Kitsap County
Department of Emergency Management
Tenant Improvement Bid # KC 2023-038

ADDENDUM #2
July 26, 2023

1 OVERALL ELECTRICAL SITE PLAN
SCALE: 1"=20'-0"

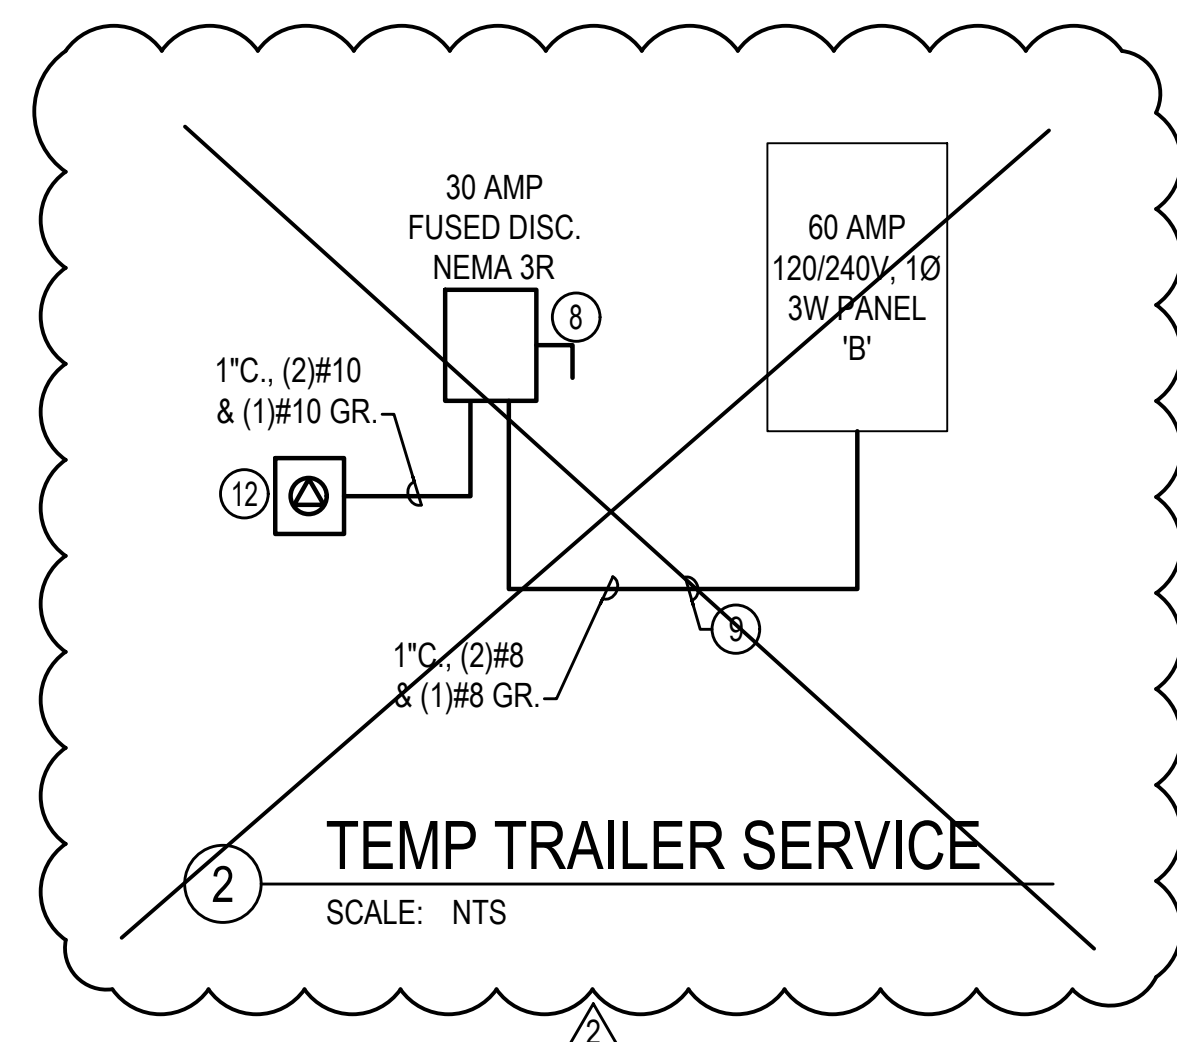
1. Sheet E1.01 Electrical Site Plan
 - a. **DELETE** detail 2 – Temp Trailer Service.
 - b. **DELETE** Construction Notes 8, 9, 11 & 12.
 - c. See attached revised sheet.
2. Sheet E5.01 Electrical One-Line Diagram
 - a. **DELETE** the 30 amp – 2 pole disconnect switch for the temp trailer and provide connection to the existing trailer receptacle.
 - b. See attached revised sheet.
